**Contents for Stormwater Management Facilities As-built Files**

Project Name: Milanville Kennels  
Structure/BMP Name: Wet Pond  
Project Location: 2878 Monticello Ave.  
BMP Location: 2878 Monticello Ave  
County Plan No.: SP - 54 - 04

**MILANVILLE KENNELS  
 BMP RECORD DRAWING**  
 WET POND  
 COUNTY PLAN NO. SP-54-04

ENVIRONMENTAL DIVISION REVIEW COMMENTS  
MILANVILLE KENNELS  
COUNTY PLAN NO. SP - 54 - 04  
June 4, 2004

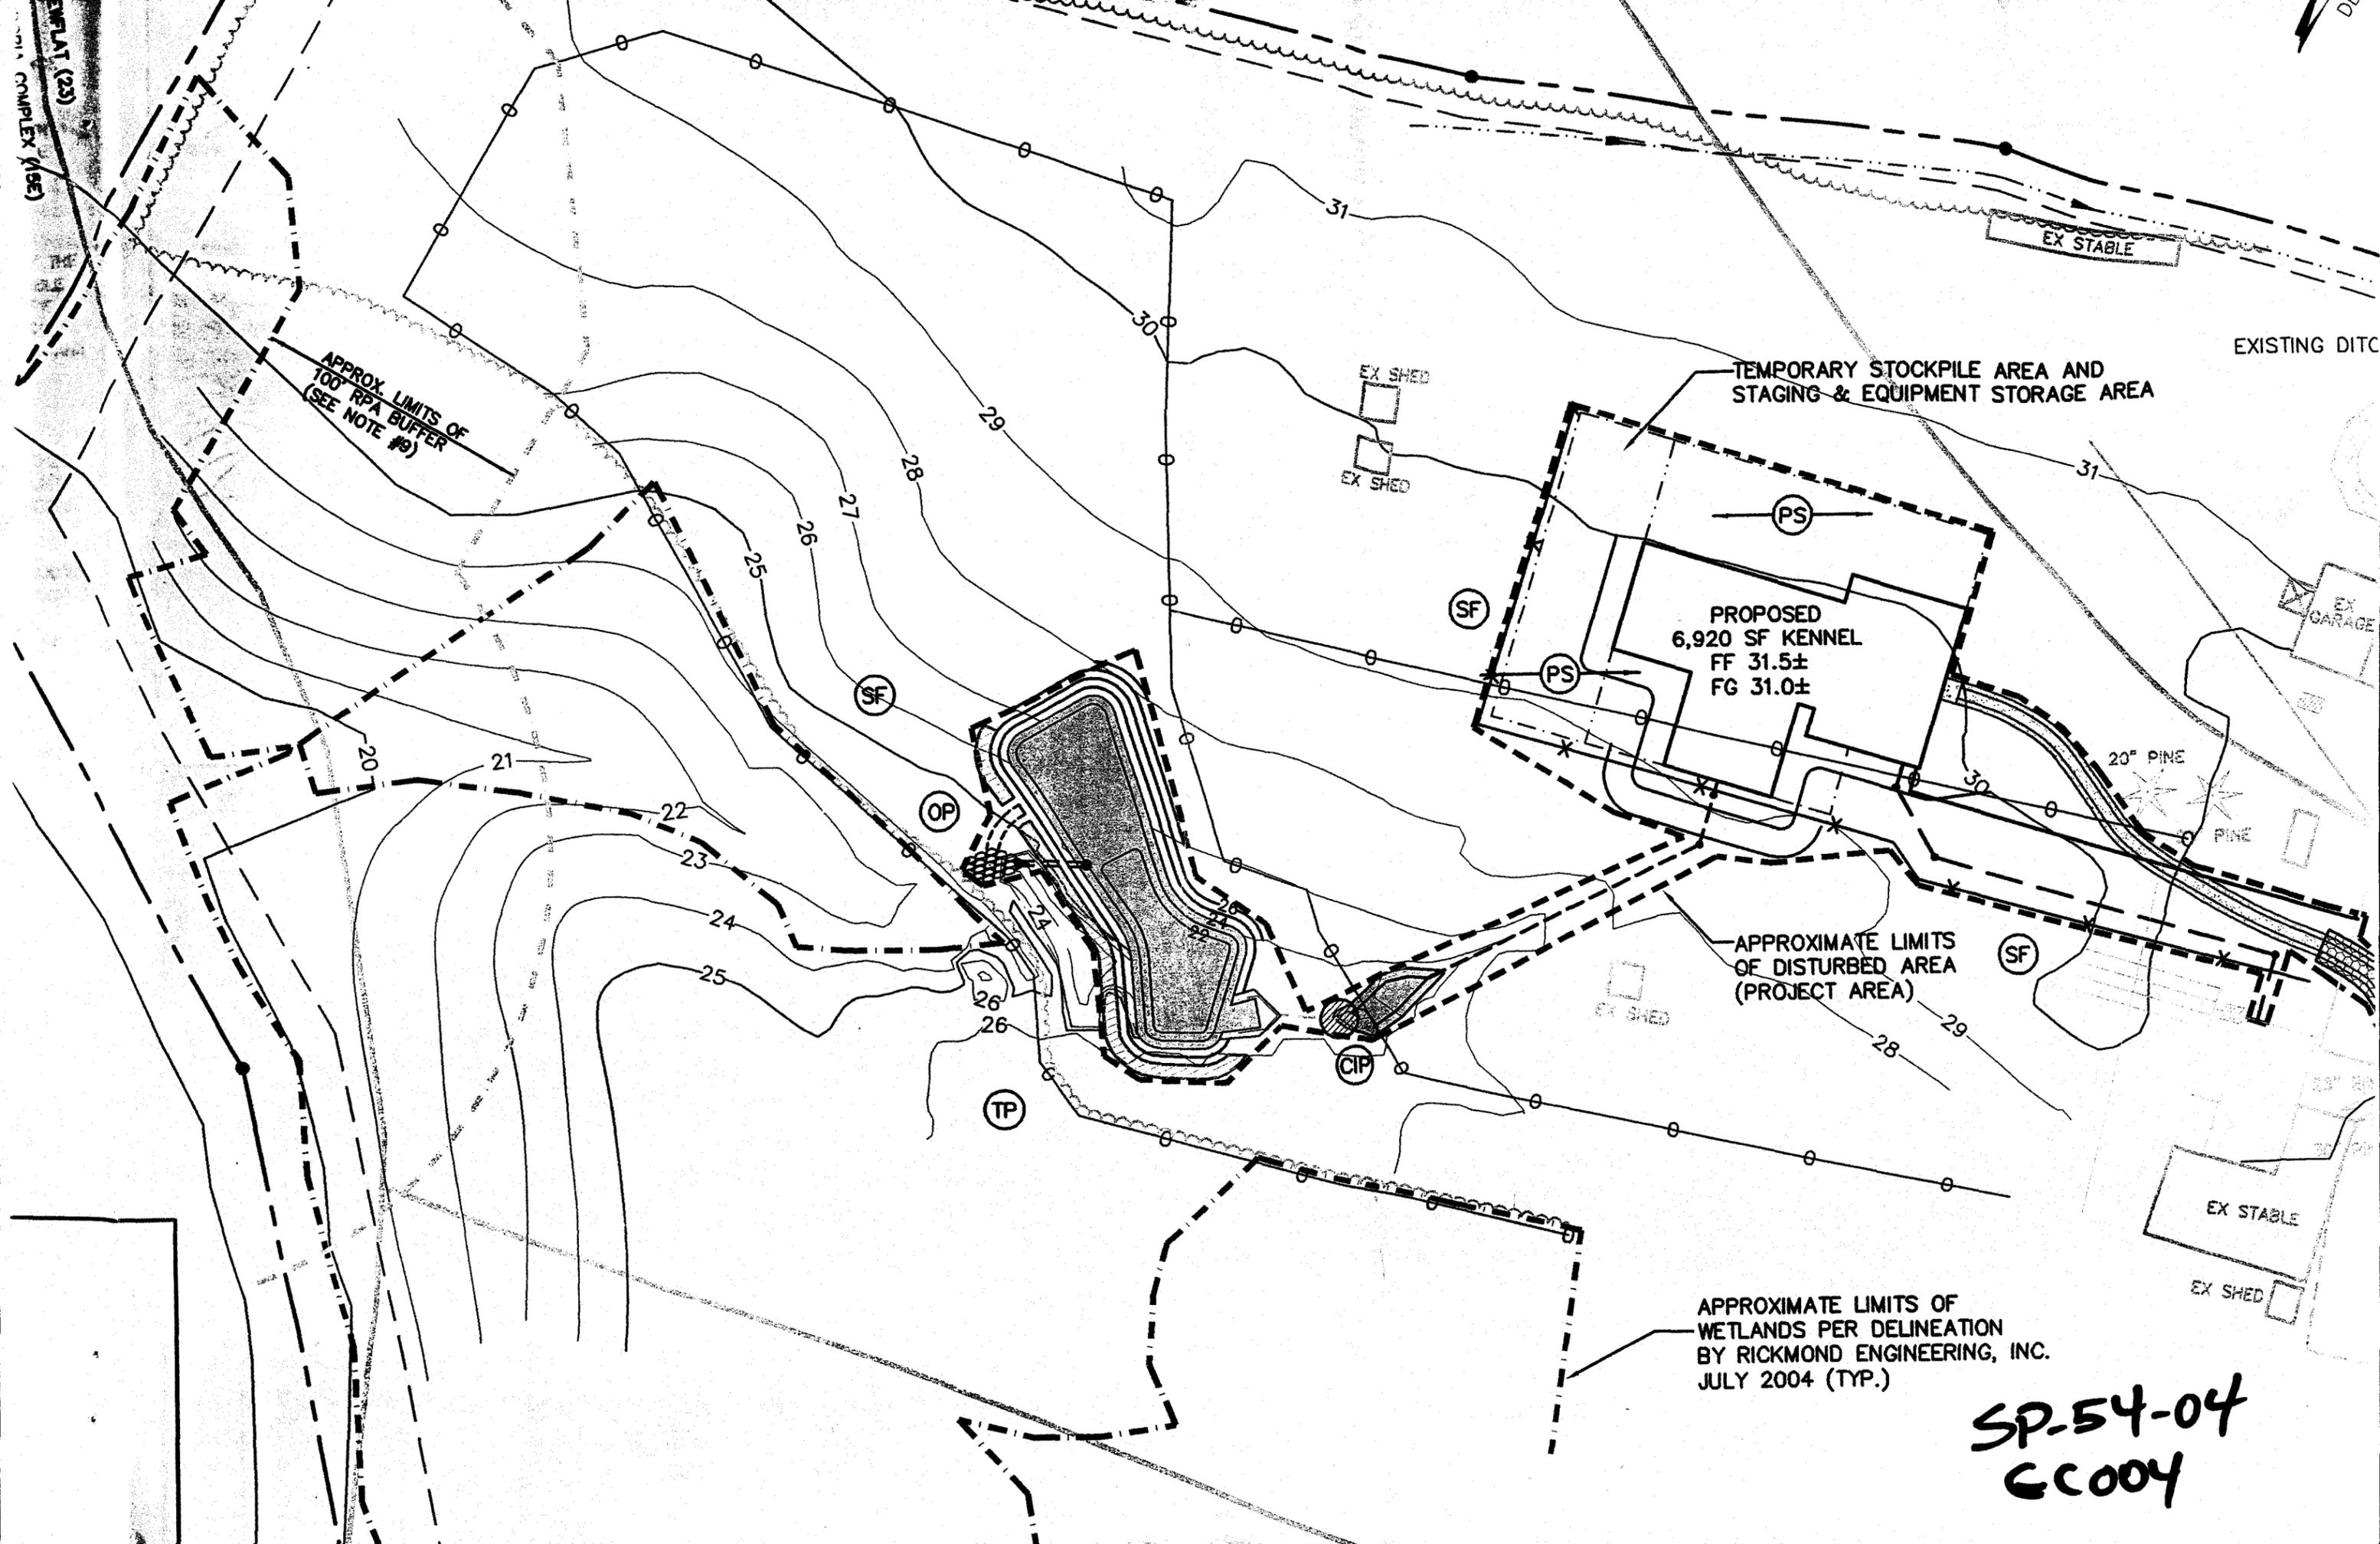
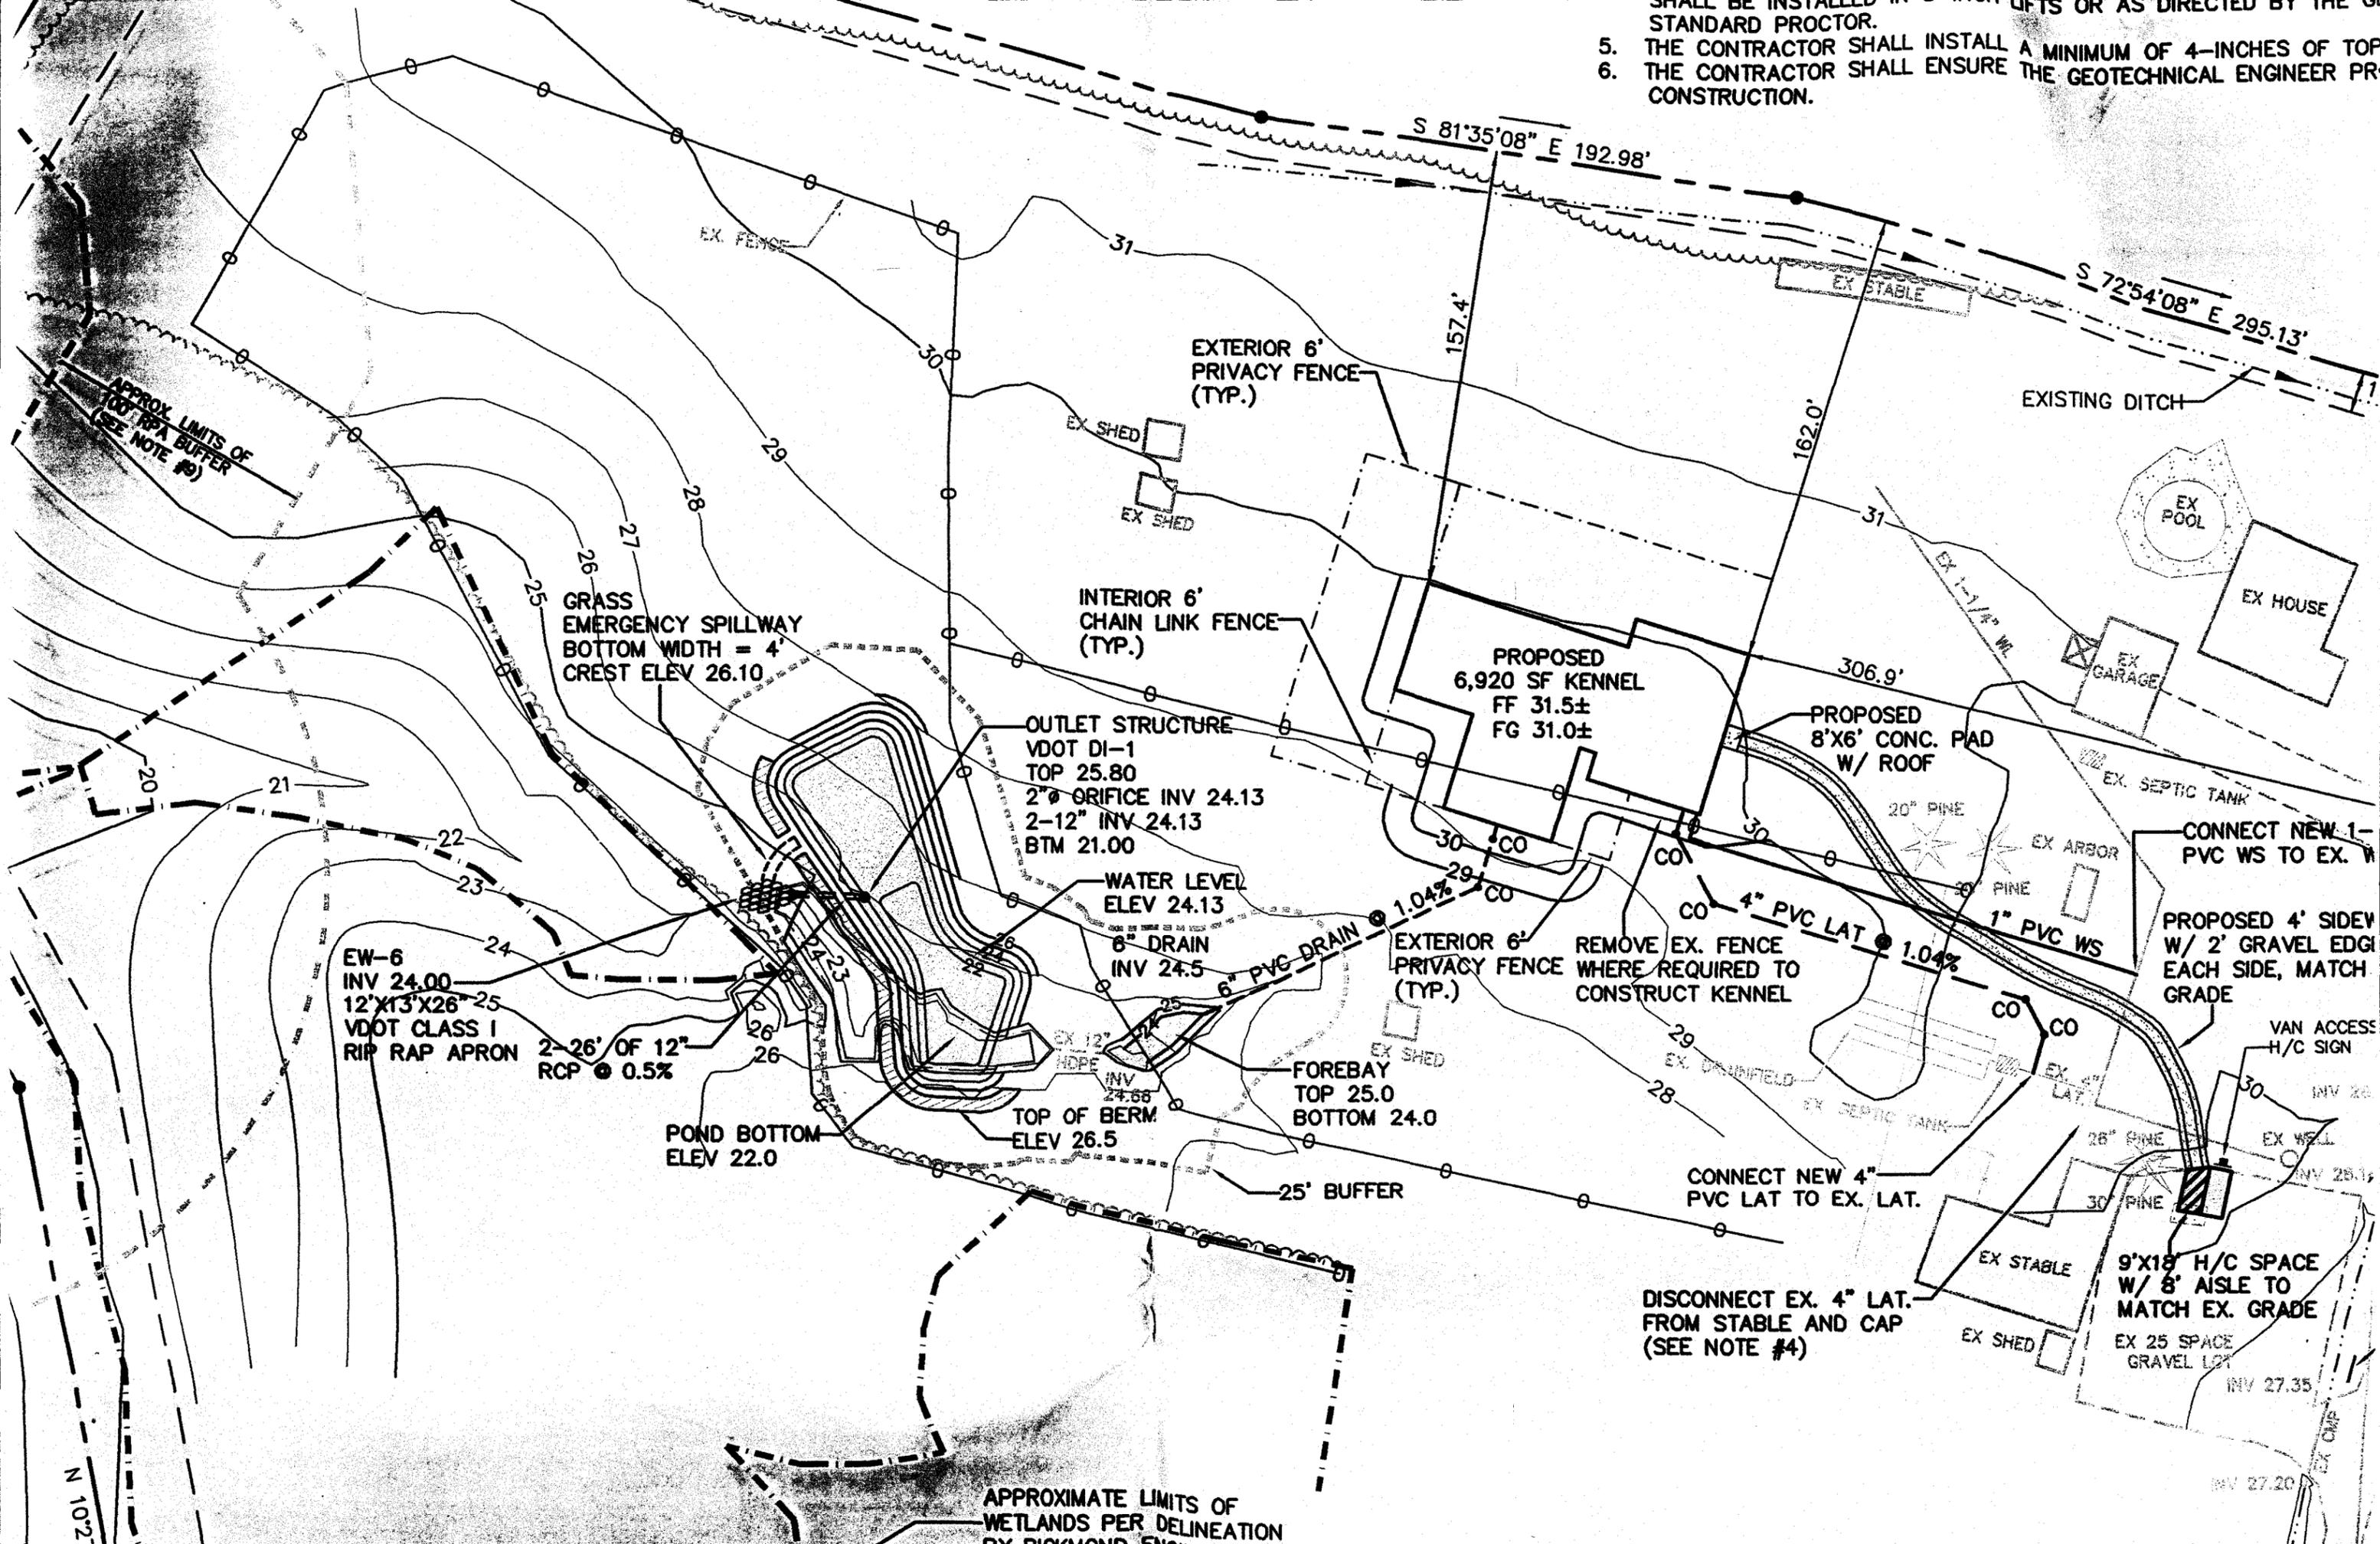
Outlet Protections. Information on plan Sheet C2 for the outlet protection pad at the pond barrel outfall conflicts with information on the BMP detail on Sheet C4 and sizing computations in the design report. Revised on sheet C2

Drainage Area. The total postdevelopment drainage area to the proposed pond (1.90 acres) appears grossly incorrect, unless permanent diversions are used to get upslope drainage area away from the pond. Based on County GIS information, it would appear that drainage area to the basin could be as much as 8 acres if offsite area to the north is included. Permanent diversion dike provided on sheet C2+C3.

BMP Outfall. Due to a lack of existing topographical information, it is unclear if the outfall from the BMP discharges to a well-defined receiving channel. Provide additional field run or County topography as necessary. Additional topography provided on sheet C2+C3

WET POND BMP DETAIL

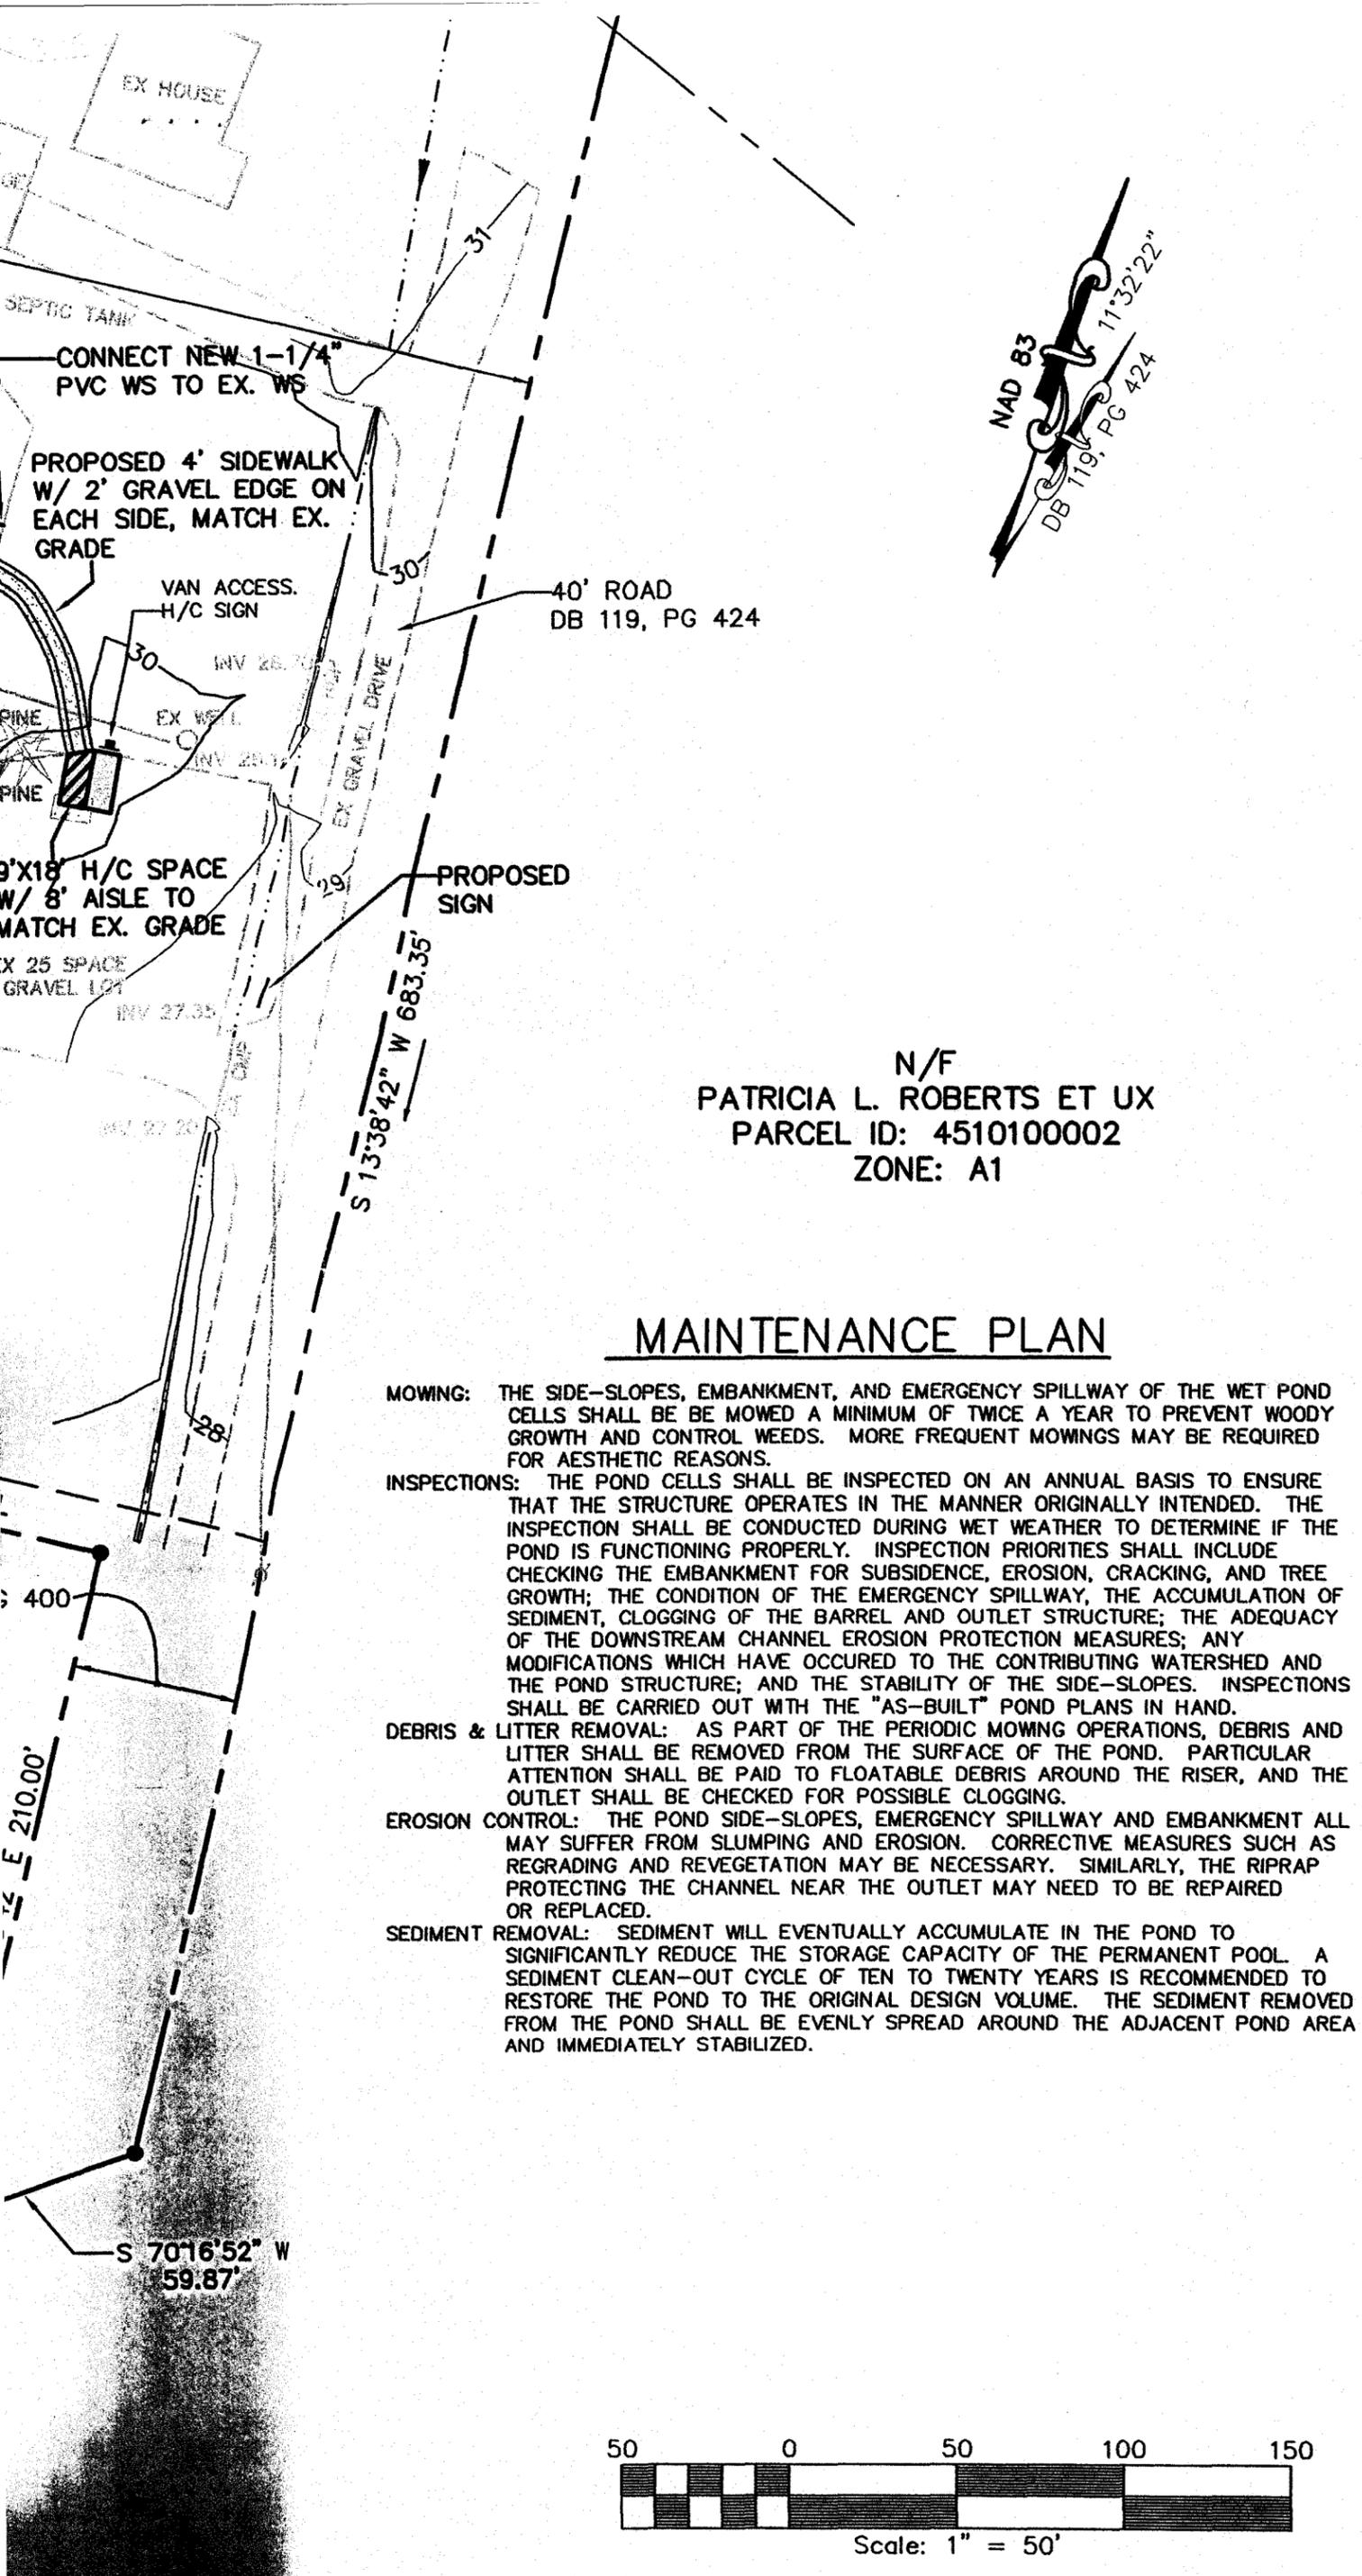
BMP. Show the design water surface elevations for the 1- and 100-year storm events on the pond detail on Sheet C4. provided

Pond Construction. Provide computations and details showing specific construction information for anti-seep collars along the pond barrel and for construction information (details) on the emergency spillway (size, depth, lining, side slope, etc.). Calculations provided in narrative & details on sheet 4
